**Planning Commission
Wednesday, November 20, 2024
4:00 PM**

Agenda Item Summary

AGENDA ITEM: Resolution No. 7, Series of 2024: Little Red School House
Special Review and Subdivision Plat

INTERIM CONSTRUCTION ACCESS AND TRANSIT PLAN

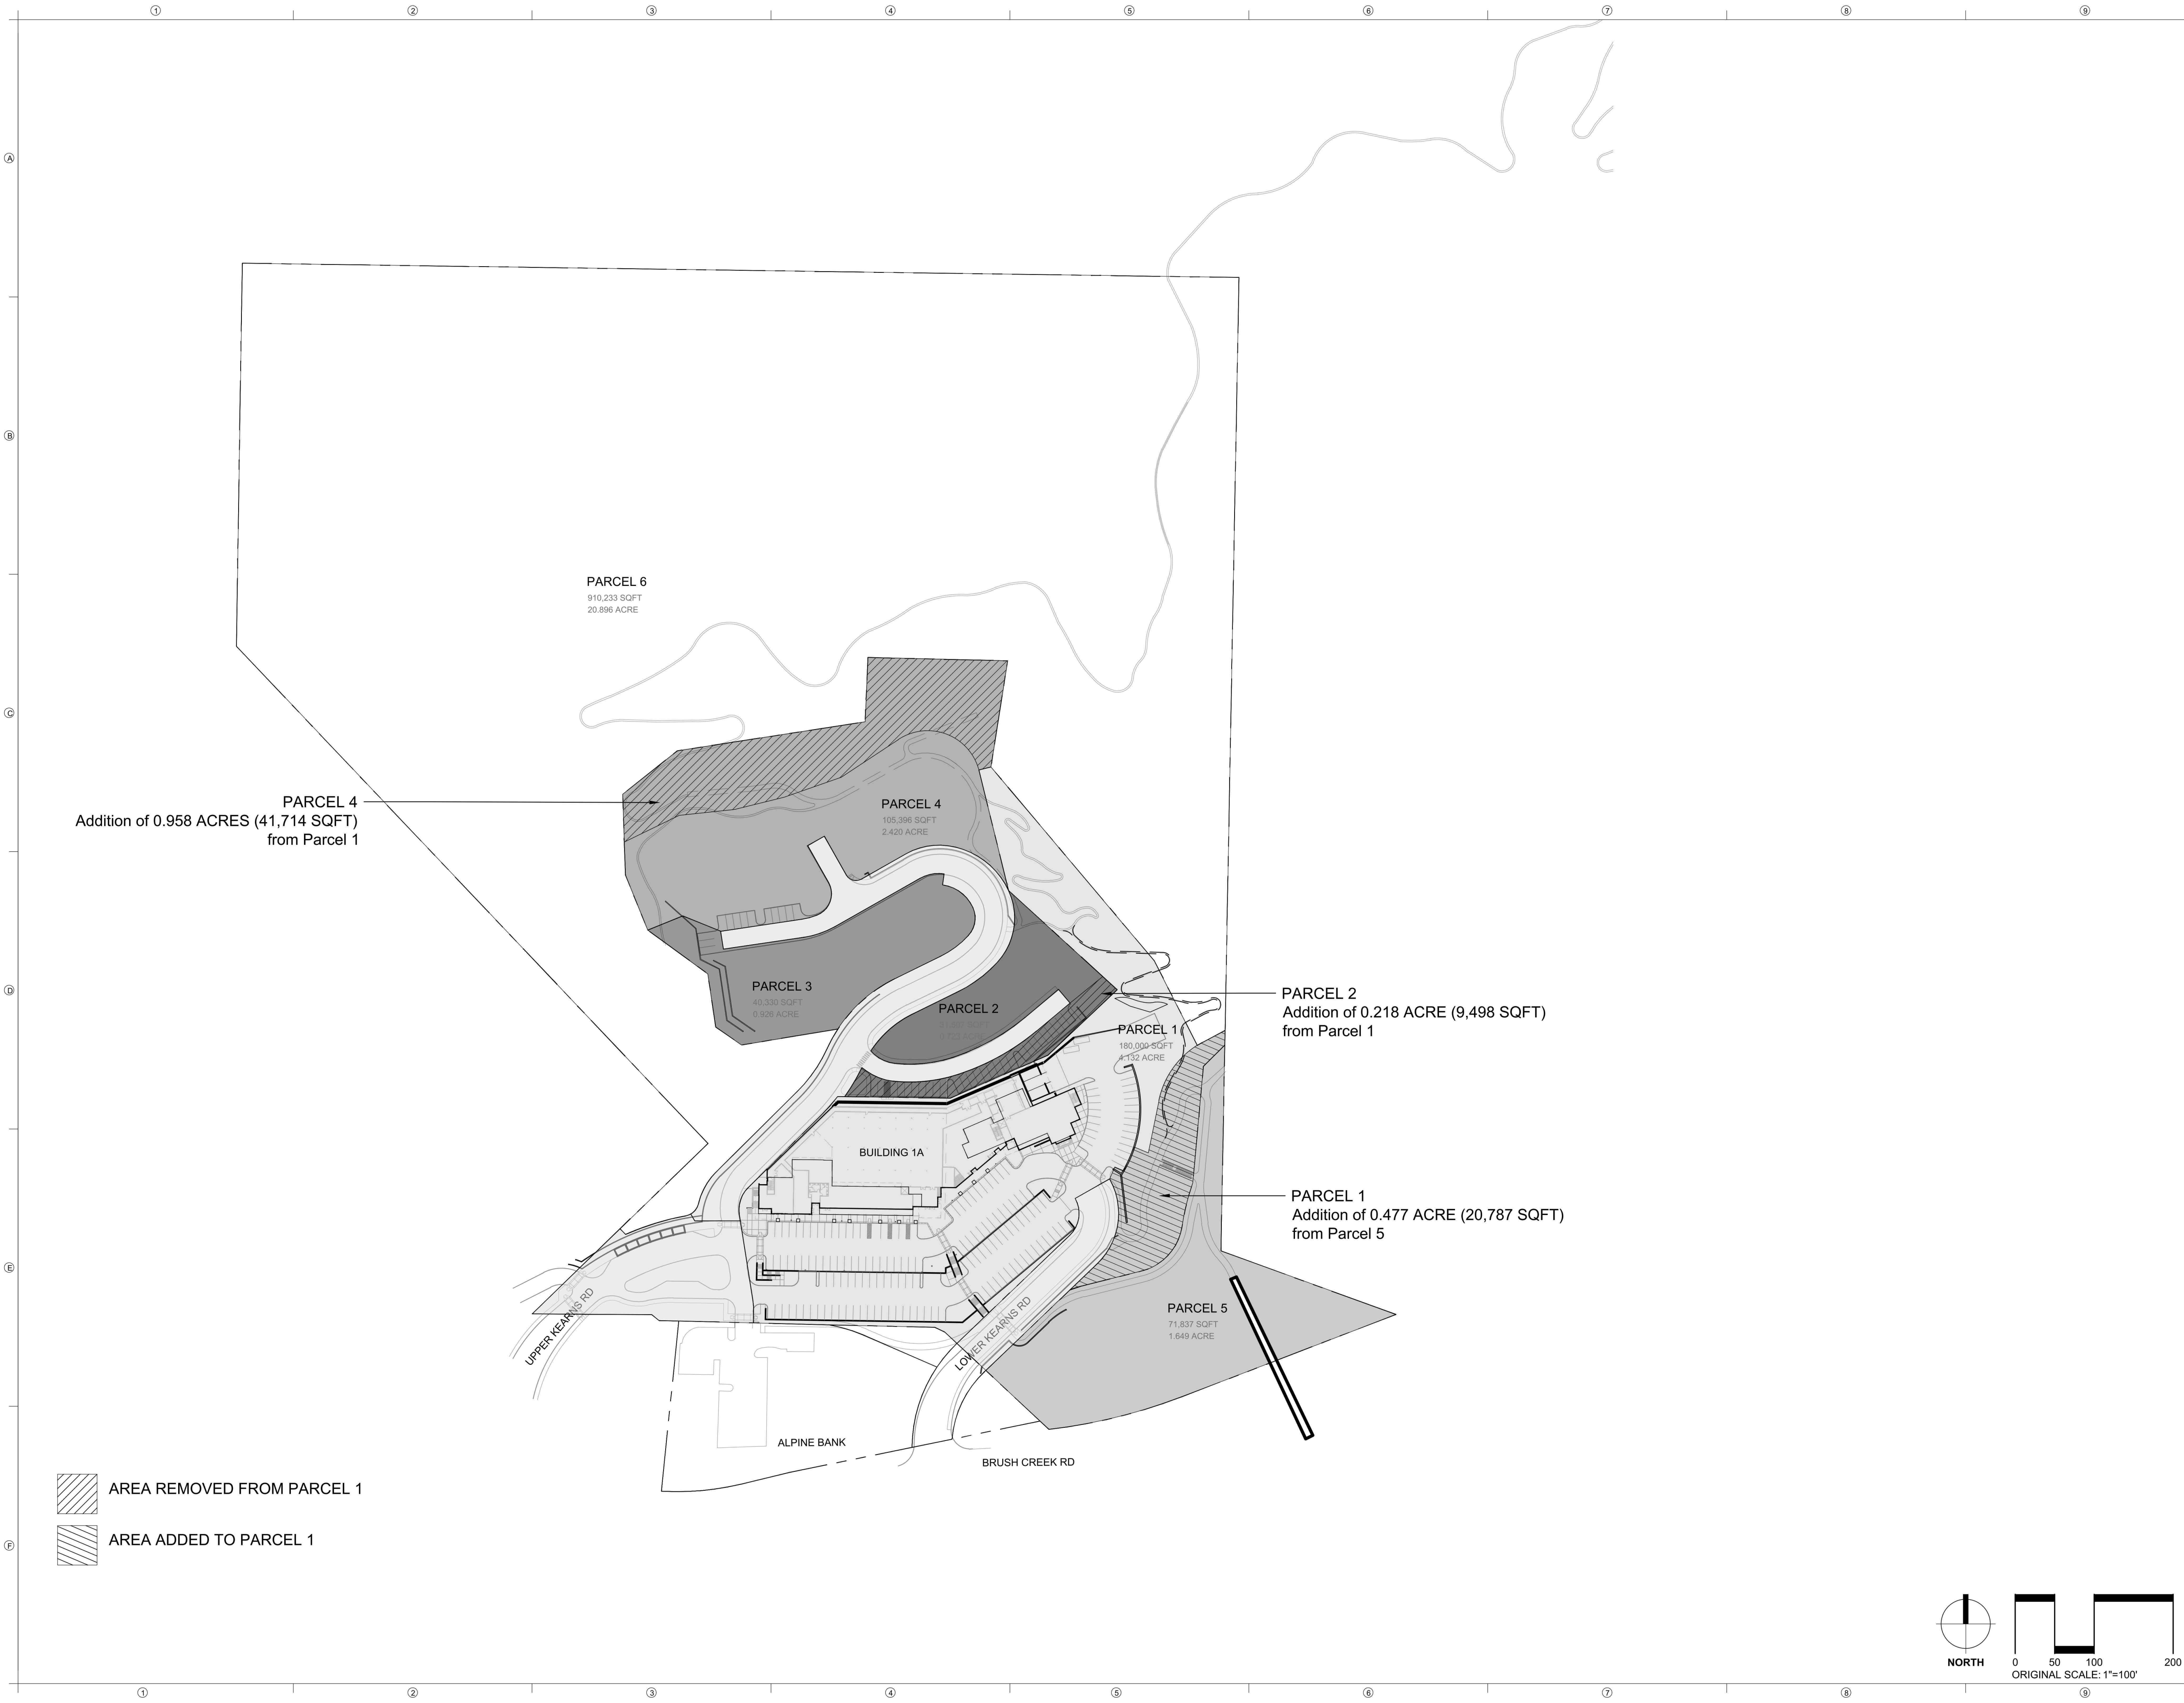
To be clear, the proposed Interim Construction Access and Transit Plan (L-1.12) will not meet currently adopted emergency access and fire protection water supply requirements as defined in the International Fire Codes and further fails the Municipal Fire Protection codes adopted by the Town of Snowmass Village.
